Appl No. 09/812,260  
Amtd. dated February 10, 2005  
Reply to Office action of January 19, 2005

**Amendments to the Drawings**

Fig. 3

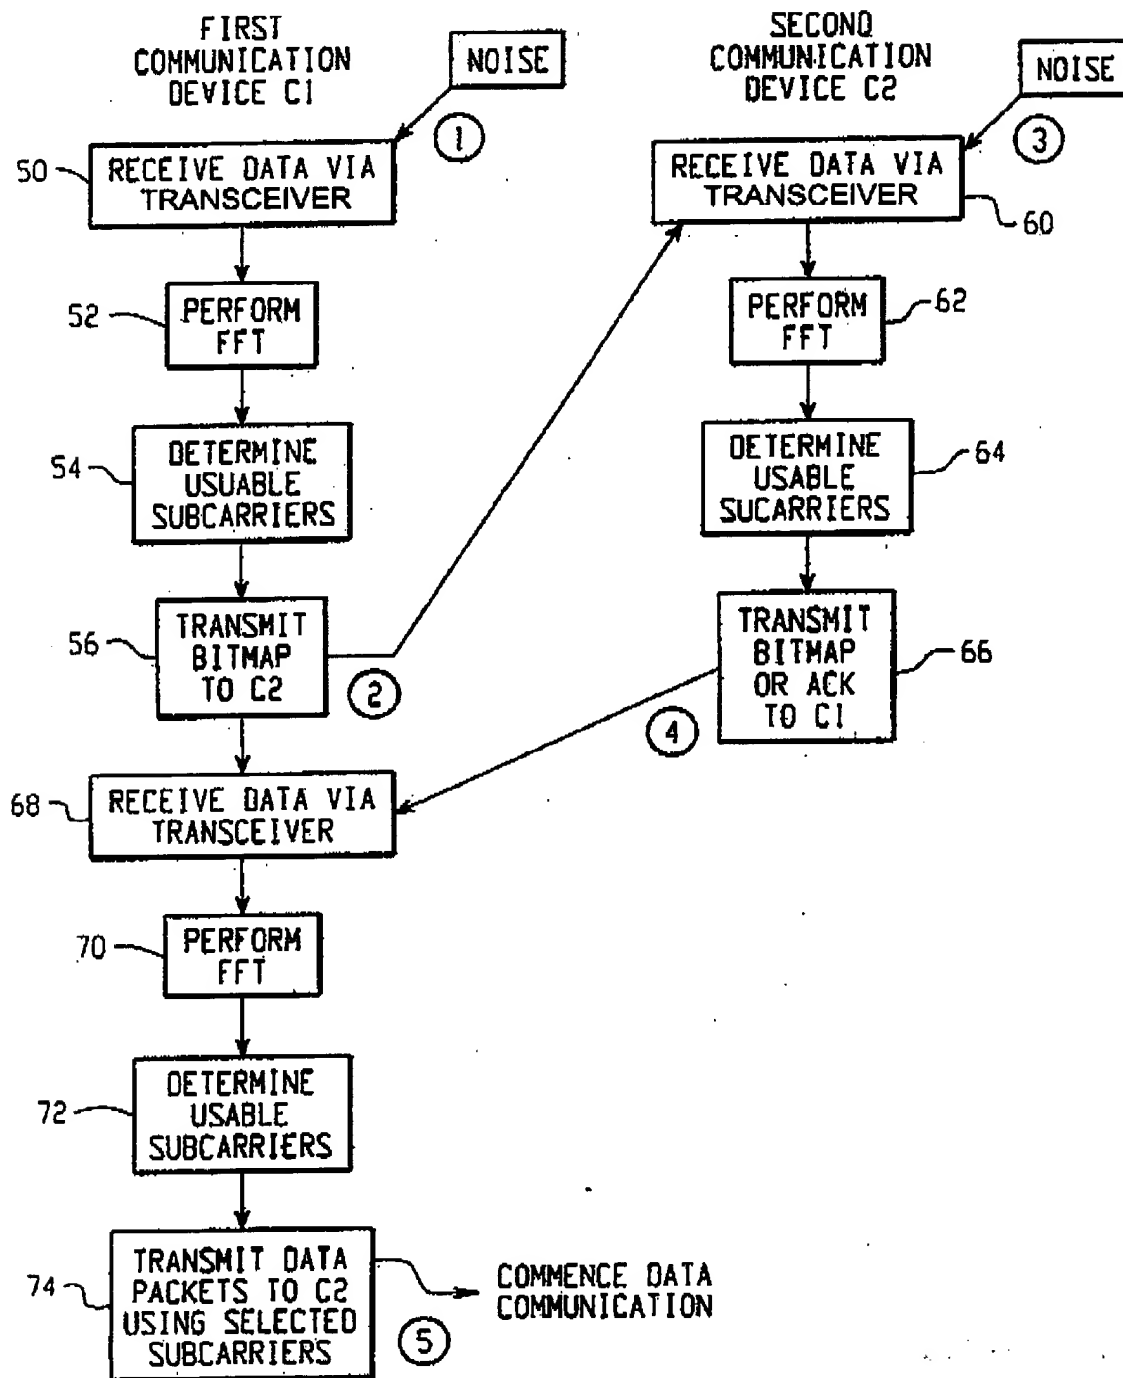
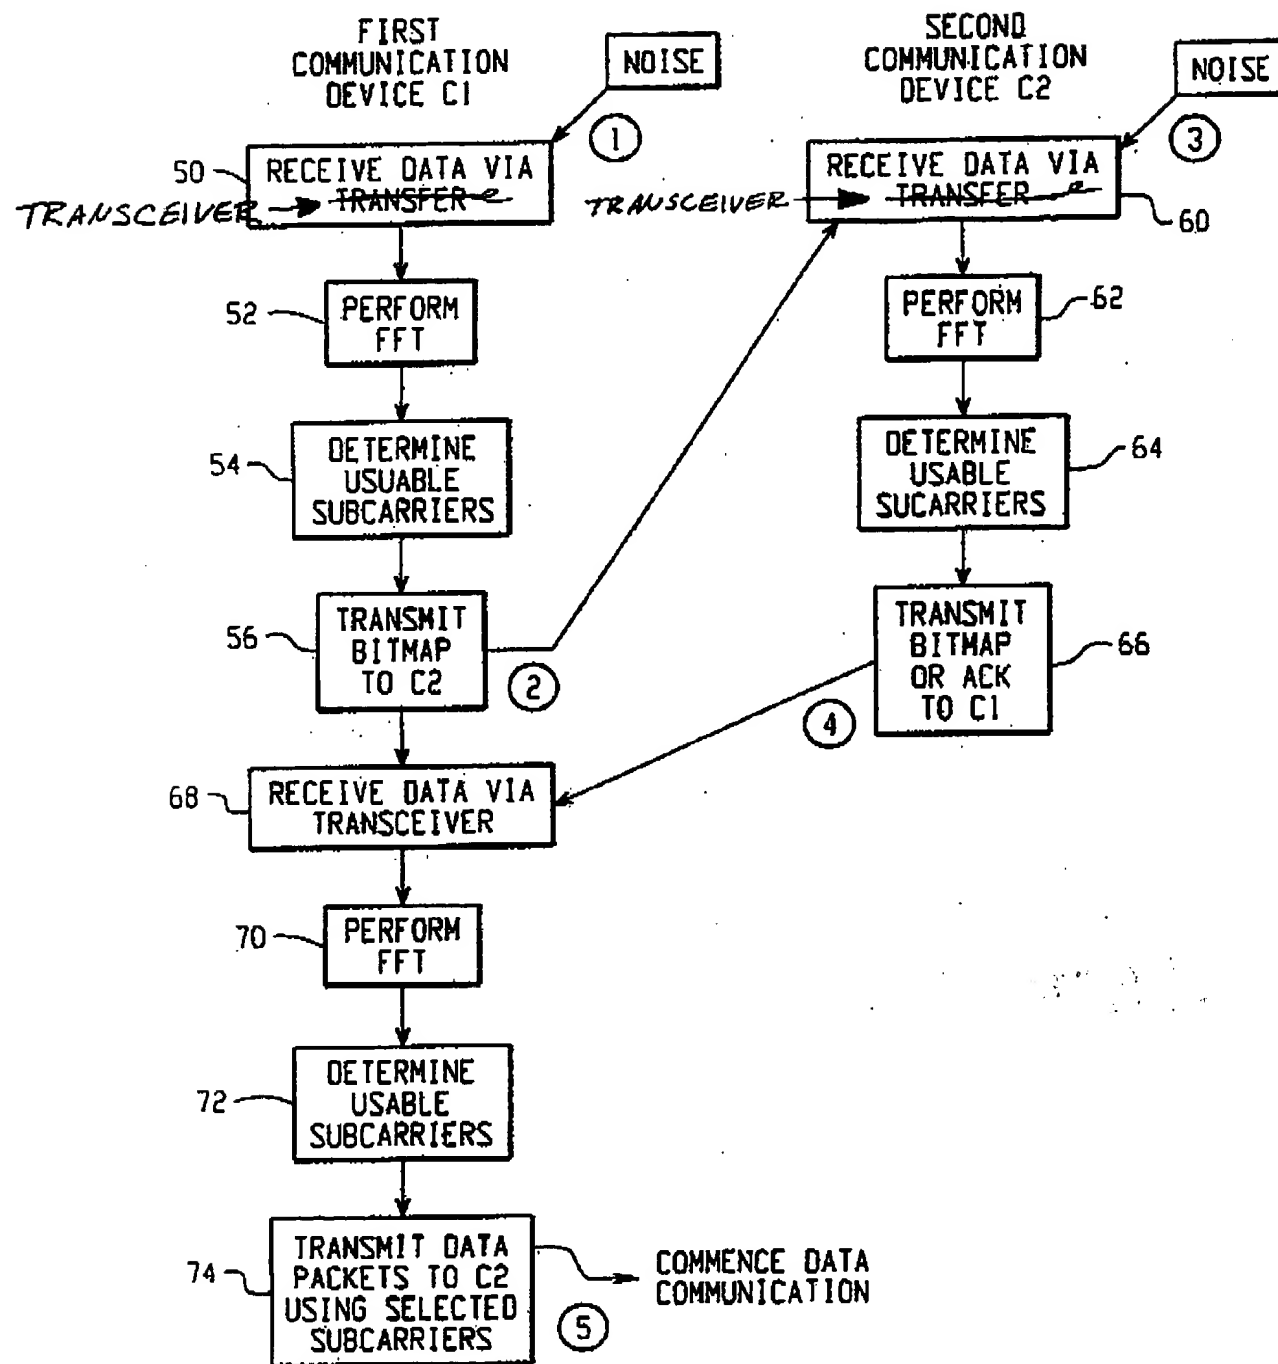
The attached sheet of drawings includes changes to Fig. 3. This sheet includes Fig. 3 and replaces all prior sheets including Fig. 3. In the previously submitted sheet, steps 50 and 60 erroneously recited "transfer" instead of "transceiver." The replacement sheet corrects this problem. The original Fig. 3 submitted with the application recites "transceiver" for steps 50 and 60.
